STAFF REPORT: FEBRUARY 9, 2022 MEETING

APPLICATION NUMBER: 22-7665, VIOLATION NUMBER: 543

ADDRESS: 715 VAN DYKE

SCOPE: DEMOLISH (WORK DONE WITHOUT APPROVAL) AND REBUILD FRONT PORCH

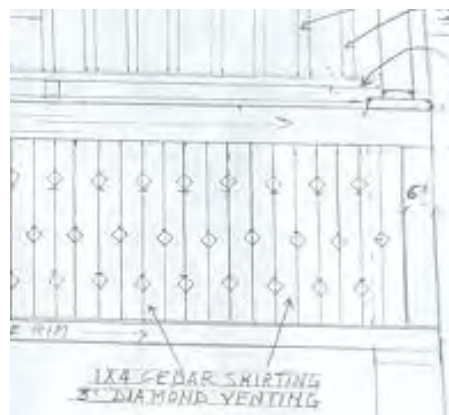
- Much discussion was held (between the applicant and staff, and then amongst staff) about the existing (at the time of demolition) porch skirting. The skirting to the left of the stairs was the oldest portion of this element. It is staff's opinion it is not a character-defining feature as it wasn't constructed in the manner of historic skirting, and likely not original to the house: it was constructed of solid pieces of wood (rather than vertical boards with the pattern cut at the board edges), and it wasn't framed out with the skirting sitting behind the frame. Staff also feels the below left design would not be stable over time due to moisture wicking into the wood and causing warping of the large panels.

- The proposed cedar skirting is sympathetic to the era of the house and the diamond openings offer ventilation in a minimally detailed way.

- The skirting design will be revised to include framing and vertical boards at column/pier locations and will be submitted for staff review.
- The paint color/finish for each porch component (including decking) will be submitted for staff review.
- The porch elements won't be painted until the wood members have dried out.
